# Central Coast Quarter 26 Mann Street Gosford

CONDITION B1 RESPONSE PACK

### ***Amendments to the concept proposal***

2. 85% VOLUMETRIC FILL

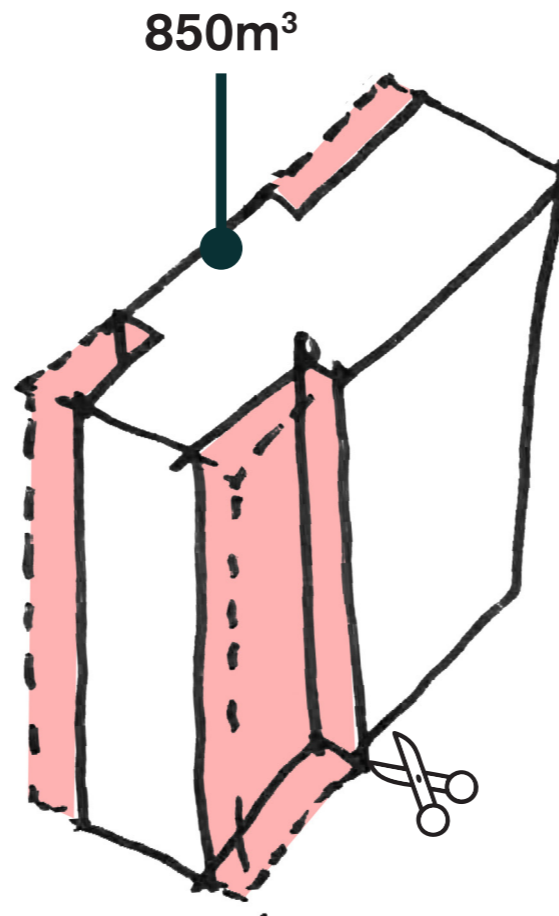
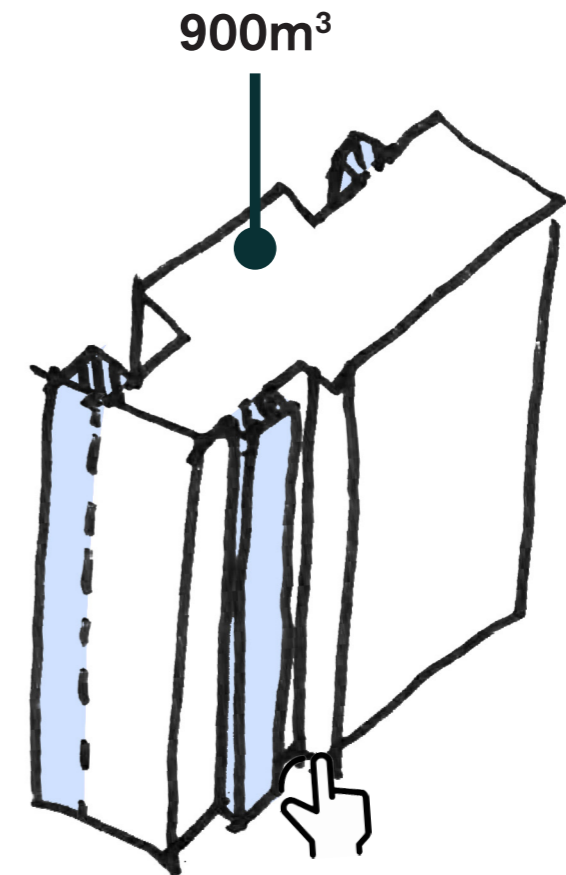
The concept envelope amended in plan and in elevation, but not in height, to show a zone within the envelope that represents 85% of the volumetric fill of the envelope, plus an additional 5% zone beyond that which is the 'articulation zone'. The articulation zone represents the outer permissible limit for any built form.

This condition only applies to the 'Southern Building' and 'Northern Building' component of the envelope, as identified in the Proposed Concept Master Plan for Approval Yield Table, Drawing TP606, prepared by DKO Architecture, Revision P2, dated March 2020. The Eastern (Hotel) Building component is approved as shown in the Plan referred to in ToA A3.

It is important to note that the reference scheme supplied with the concept DA only partially filled the envelope of Northern and Southern building (95% and 97% respectively). It is our understanding that the purpose of the volumetric fill is to reduce it further to 85% with an additional 5% articulation zone for architectural elements (as described in the diagrams below).

CONDITION B1 (a)  
VOLUMETRIC FILLS

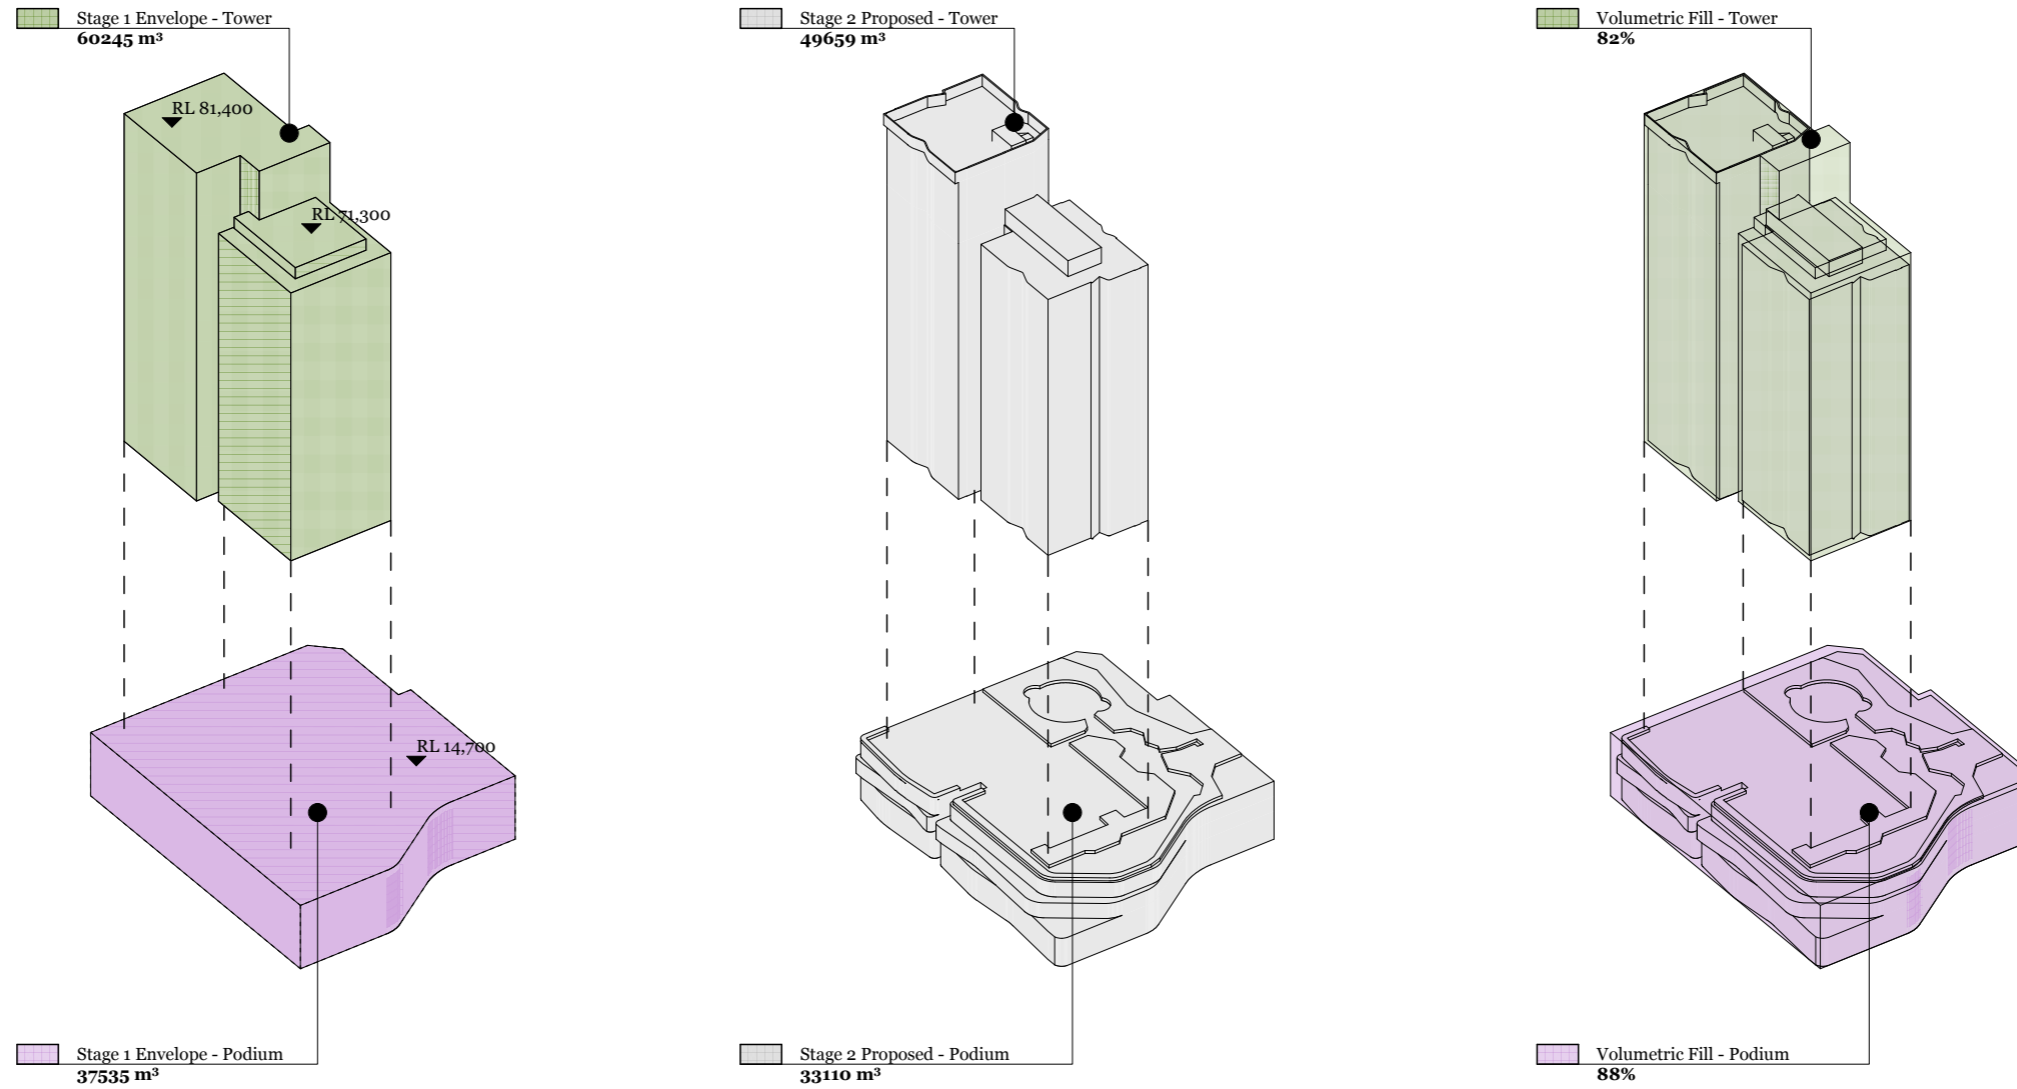
The concept envelope amended in plan and in elevation, but not in height, to show a zone within the envelope that represents 85% of the volumetric fill of the envelope, plus an additional 5% zone beyond that which is the 'articulation zone'. The articulation zone represents the outer permissible limit for any built form.

This condition only applies to the 'Southern Building' and 'Northern Building' component of the envelope, as identified in the Proposed Concept Master Plan for Approval Yield Table, Drawing TP606, prepared by DKO Architecture, Revision P2, dated March 2020. The Eastern (Hotel) Building component is approved as shown in the Plan referred to in ToA A3.

The developed scheme has been amended to show the Northern and Southern envelope containing a reduced building footprint of up to 85% with balconies and architectural elements extending out a further 5% into the articulation zone.

Northern Tower Volumes

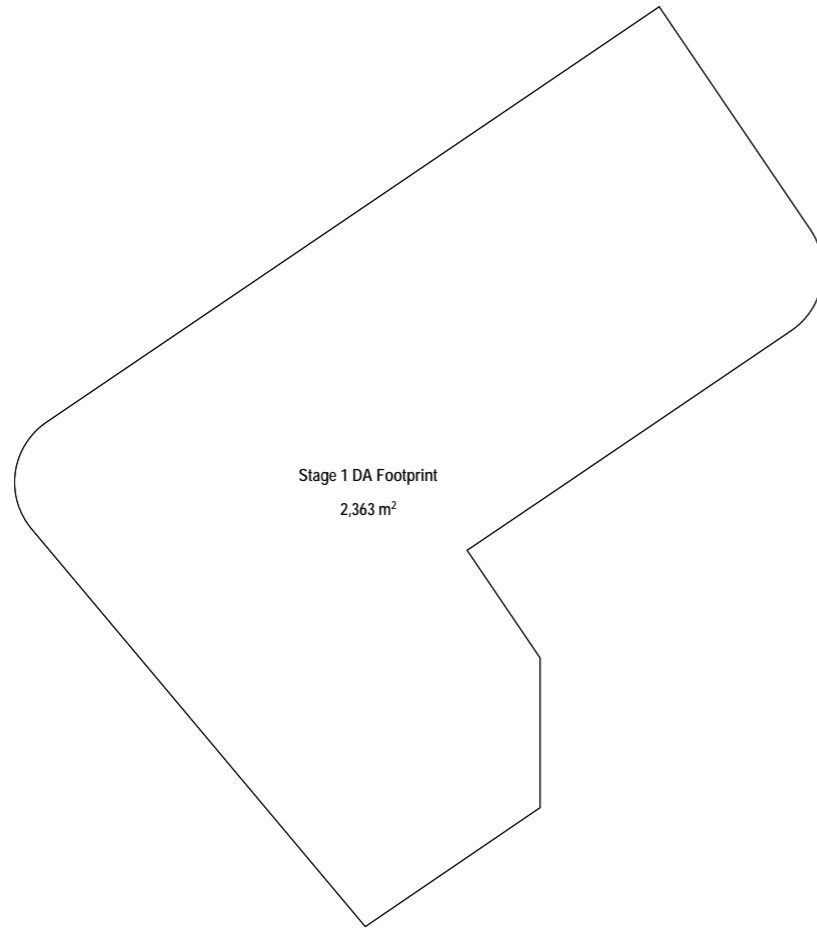
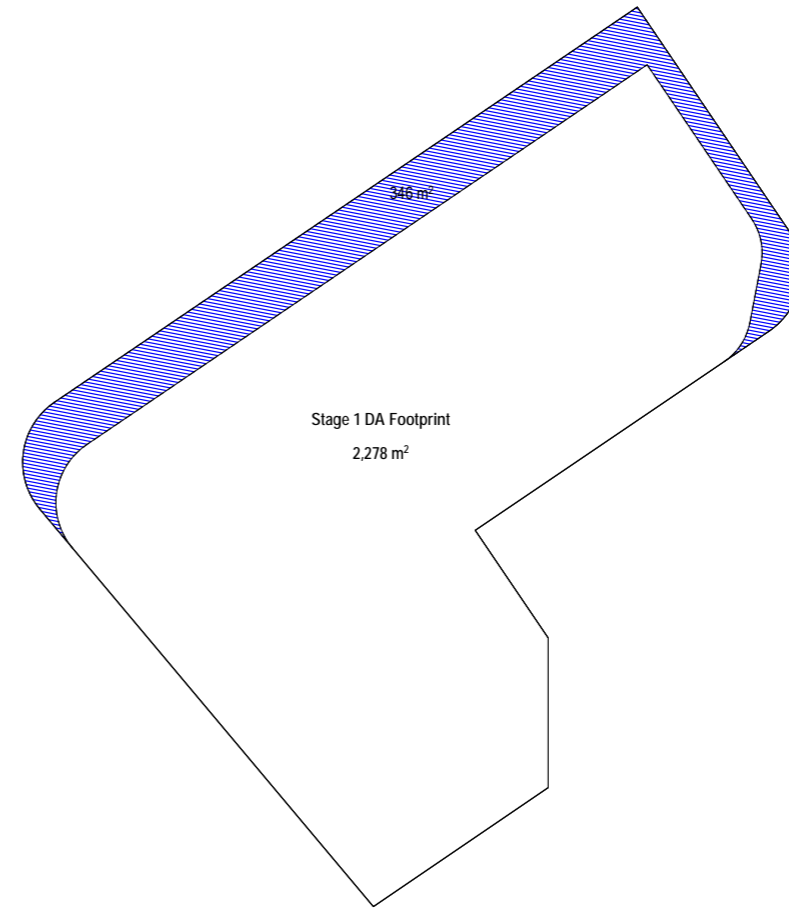
The concept envelope amended in plan and in elevation, but not in height, to show a zone within the envelope that represents 85% of the volumetric fill of the envelope, plus an additional 5% zone beyond that which is the 'articulation zone'. The articulation zone represents the outer permissible limit for any built form.

This condition only applies to the 'Southern Building' and 'Northern Building' component of the envelope, as identified in the Proposed Concept Master Plan for Approval Yield Table, Drawing TP606, prepared by DKO Architecture, Revision P2, dated March 2020. The Eastern (Hotel) Building component is approved as shown in the Plan referred to in ToA A3.

The southern building is yet to be developed and therefore a standard approach to the volumetric fill has been applied to the existing envelope. We note that this will need to be amended once the scheme is fully developed (when the detailed DA is available for this stage).

CONDITION B1 (b) & (C)  
NORTHERN TOWER BUILDING ENVELOPE

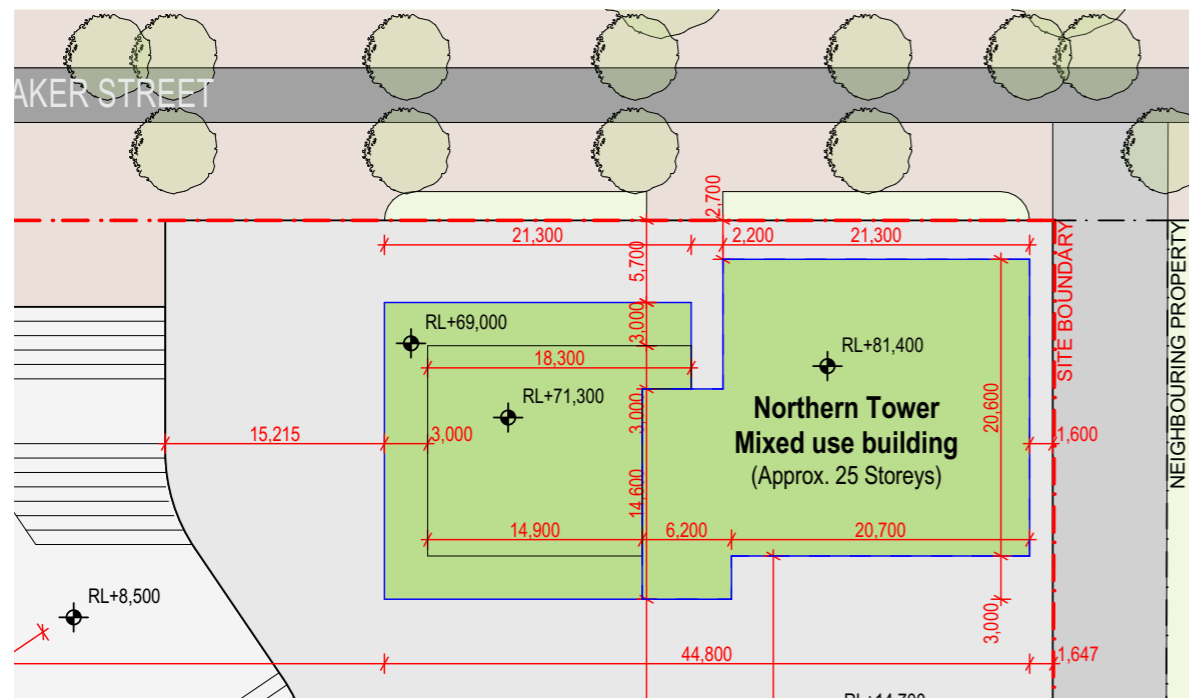
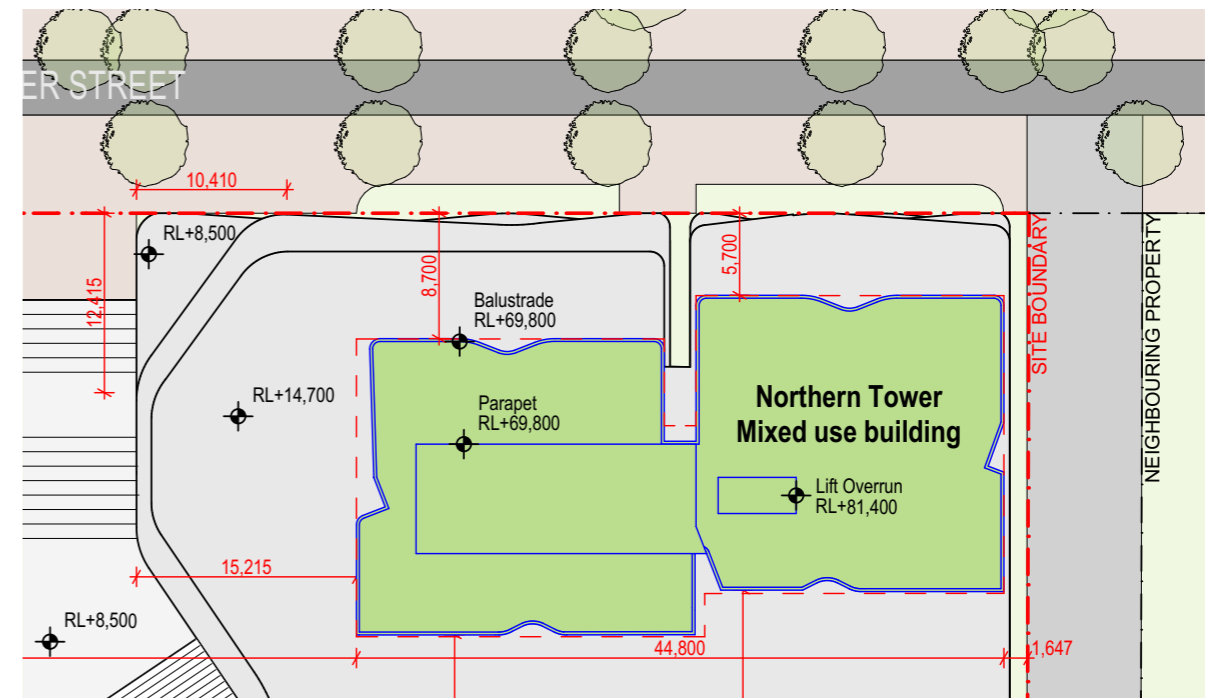
A minimum additional 3m setback for the Northern Tower building envelope (both halves) from the western podium street-wall edge, providing for the following minimum setbacks:

- 5.7m setback (northern half of the Northern Tower envelope)
- 8.7m setback (southern half of the Northern Tower envelope)

the chamfering of the south-west corner of the Northern Tower podium as shown at page 10 of the Applicant's document titled 'Central Coast Quarter 26 Mann Street Gosford' prepared by DKO Architecture and dated 26 June 2020

The Northern Tower envelope is setback an additional 3m from the edge of the Western Podium street wall to a new setback of 5.7m setback (northern half of the Northern Tower envelope) and 8.7m setback (southern half of the Northern Tower envelope).

The South-West corner of the Northern-Tower podium is chamfered, increasing solar access into the through-site link during mid winter. The Envelope Plan and Envelope Elevations are updated for approval.

- Northern Building envelope adjusted 3m away from podium
- Southern portion of Podium at the base of the Northern Tower chamfered

**Option 1 - Solar to Laneway  
after South Podium Chamfer**

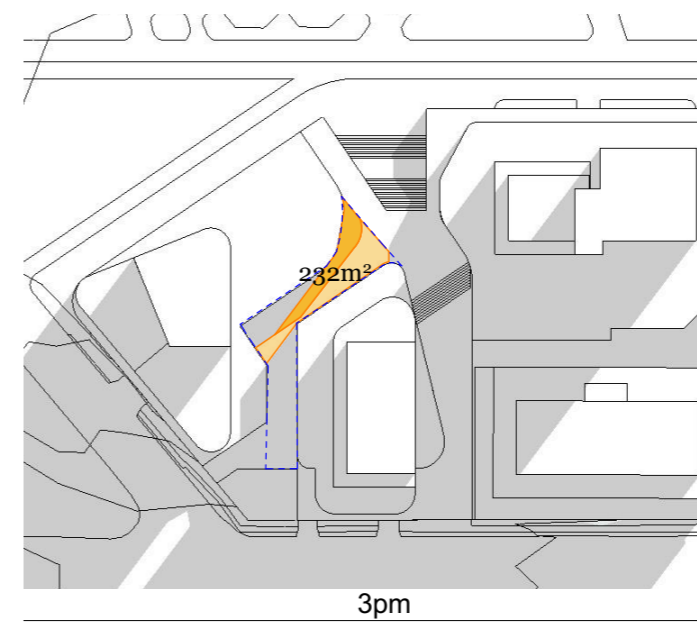
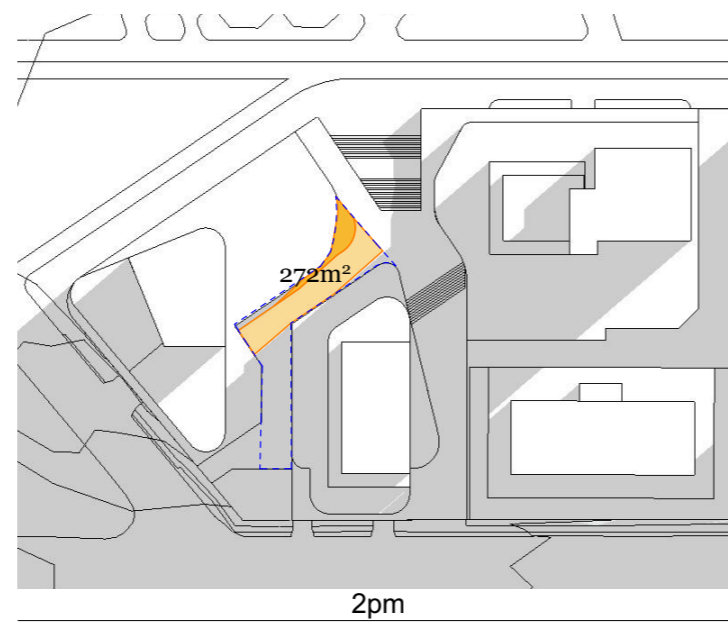
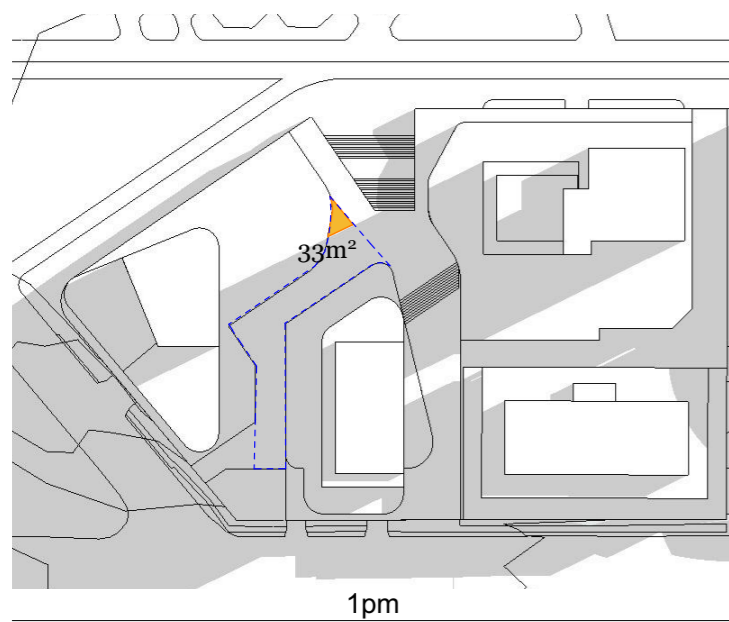
Increased solar access to the southern through-site link (i.e. the north-west oriented component, located between the Eastern Tower and the Southern Tower) in mid-winter (having regard to any visual, view and heritage impacts of any proposed change), which may include:

- re-orientation, chamfering and/or setback of the Northern Tower envelope above podium level
- reduction of the height of the western end of the Eastern Tower envelope podium from three to one storey
- other option(s) that may achieve the aim of increasing solar access to the through-site link as may be agreed with the Planning Secretary

**The widening to the entrance of the through site link ensures additional solar access from 1pm till 3pm (176m<sup>2</sup>). This provides a meaningful level of solar access and meets the intent of the condition.**

Option 2 - Drop link to RL 9.6  
View 1 (at Mann Street)

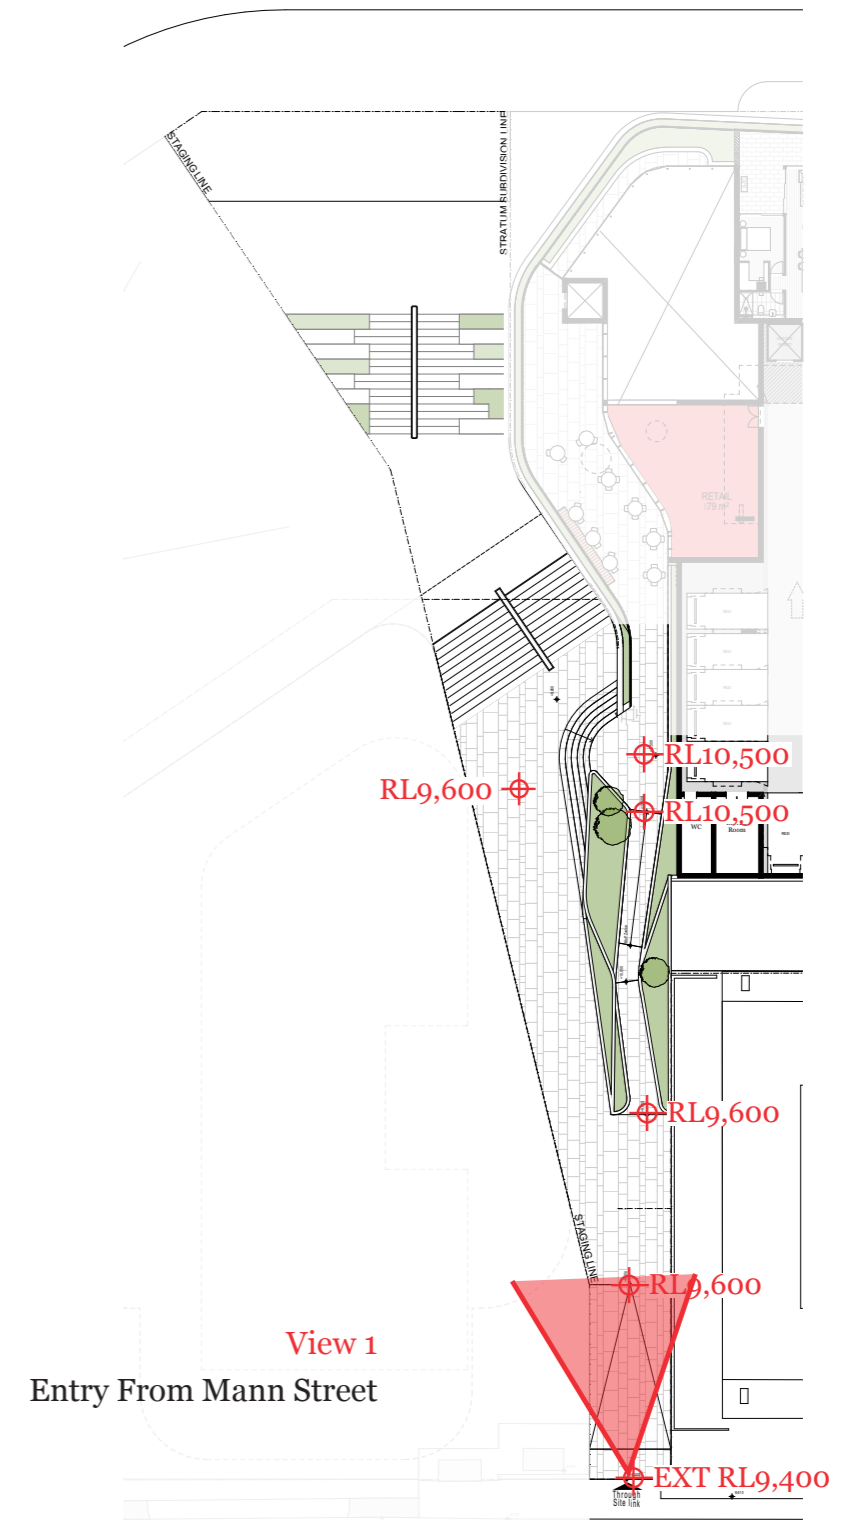
Amendment to the northern through site link or to the building envelope to show that a view line directly to the Waterfront/Leagues Club Field is retained from when standing at the boundary of the site on the footpath on Mann Street.

As an alternative option to improve the view line towards the Waterfront/Leagues Club Field, the design team has studied adjusting the through site link level to RL +9.600 which allowed a view of the water. It does require additional ramping to ensure continued accessibility through to leagues club field. This option provides water views and hides the Central Coast Highway).
